Title: Cavalon (Rotorhead III) & MTO2017 Pitch Trim Pressure Correction		
AG-SB-2019-02-B-EN		Compliance Category:
Applicability		A – MANDATORY B – RECOMMENDED C – OPTIONAL
Aircraft type & model: Cavalon & MTO2017 with Rotorhead III	Affected Serial number(s): All Cavalon from V00349 & all MTO2017 (Rotorhead III)	
The maintenance manual to be referenced is this stated or subsequent issue.		As per AutoGyro website
<p>This form is the response from AutoGyro GmbH either against a problem found in the product in service requiring a containment or rectification action, or as service information for aircraft modification incorporation. For help, contact AutoGyro on 49(0)5121 88056-00, or email airworthiness@auto-gyro.com.</p>

(Pic.1)

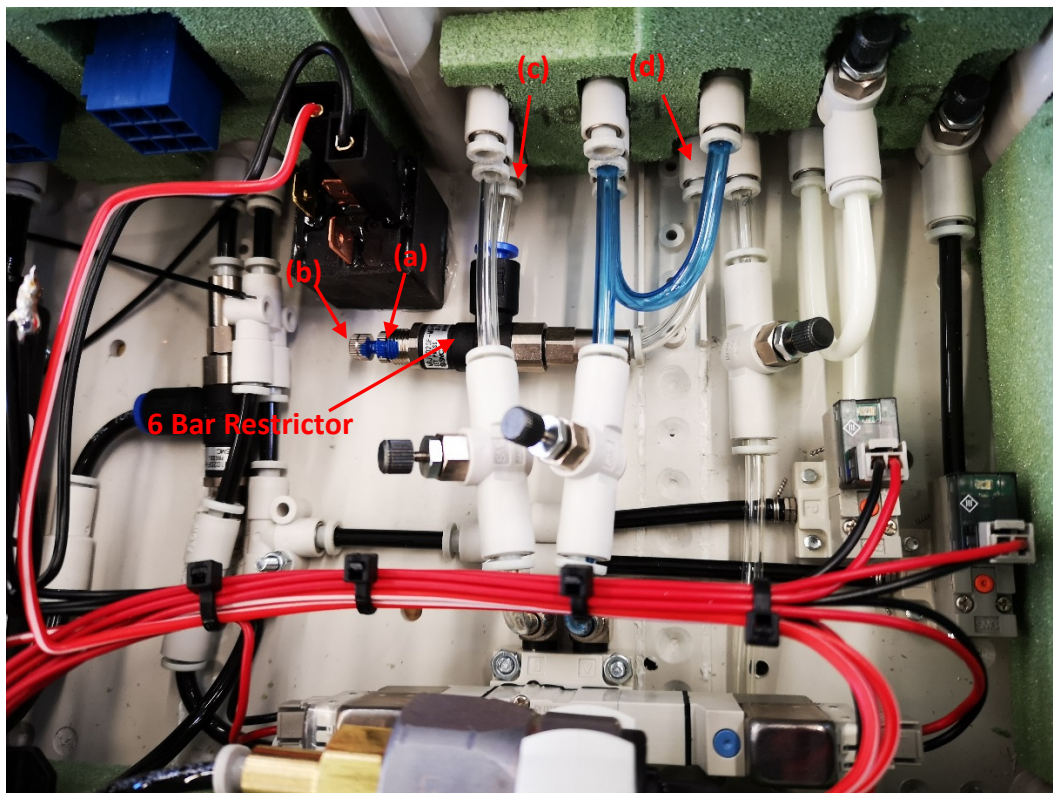
1. Remove the upper pneumatic connection (clear hose) of the brake/trim cylinder and attach a manometer with a non-return valve (Pic.1)
2. Unhook the rotor bag from the nose and ensure the rotor is able to pitch rearwards under control (a second person holding the bag chord).
3. Switch the flight/brake switch to flight, ensure the propeller is clear of obstruction and turn on the ignition.
4. Apply nose up trim by moving the 4-way switch on the top of the stick to the rear.
5. Note the maximum pressure reading on the manometer. If it is 8 bar then no further action is required. Reconnect the upper brake/trim cylinder pneumatic hose and mark with mechanic paint.
6. If the pressure is more than 0.25 bar less than that displayed in the cockpit then carry out steps 7-13:

(Pic.2)

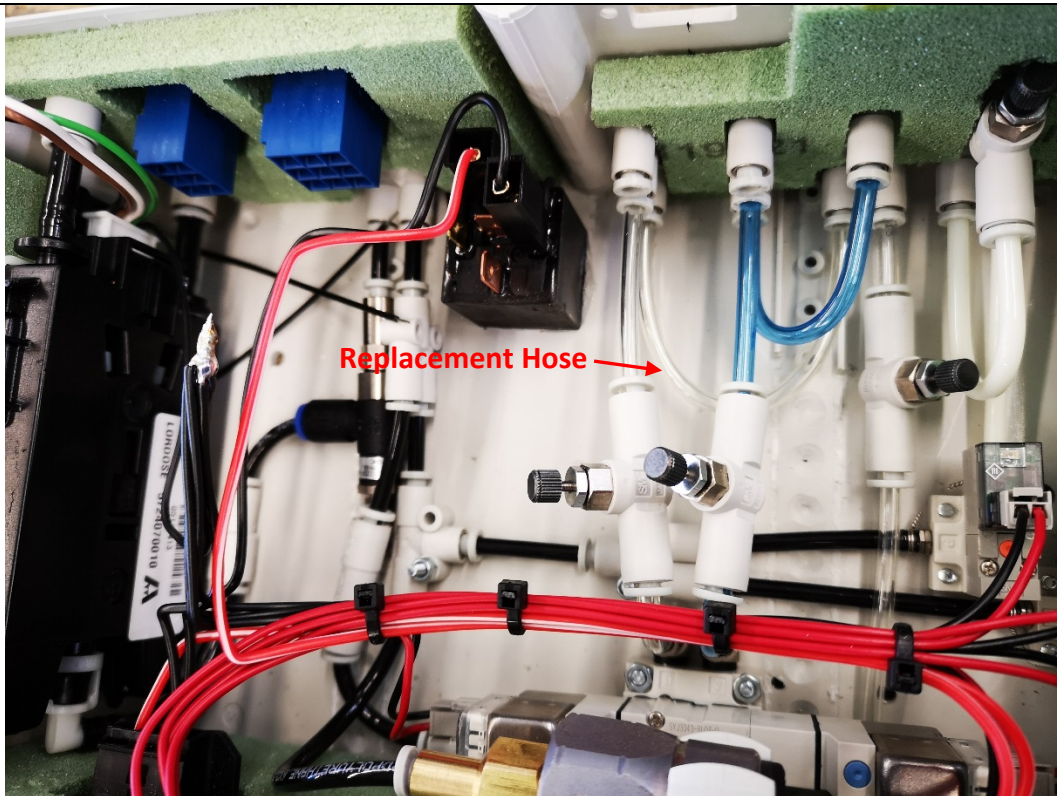
7. Gain access to the 6 bar pressure restrictor (pic.2) by removing the cover of the pneumatic box (in the nose area behind the cockpit of the Cavalon 915, behind the engine bay firewall in the Cavalon 914, or in the nose compartment of the MTO2017 – 6 screws).
WARNING: If the box has the heating option fitted then the elements are attached to the lid and must be disconnected from the box at the black 3 pin connector.

8. **Either:** release the lock-nut of the adjustment knob of the restrictor (a) and screw the adjustment knob (b) in until 8 bar is measured in steps 1-5 above. Re-lock the lock-nut and mark with mechanic paint.

9. **Or the preferred solution:** remove the restrictor and connecting hoses at points (c) and (d) (pic.2) and replace with a single piece of clear pneumatic hose of approx. 130mm length (pic.3).
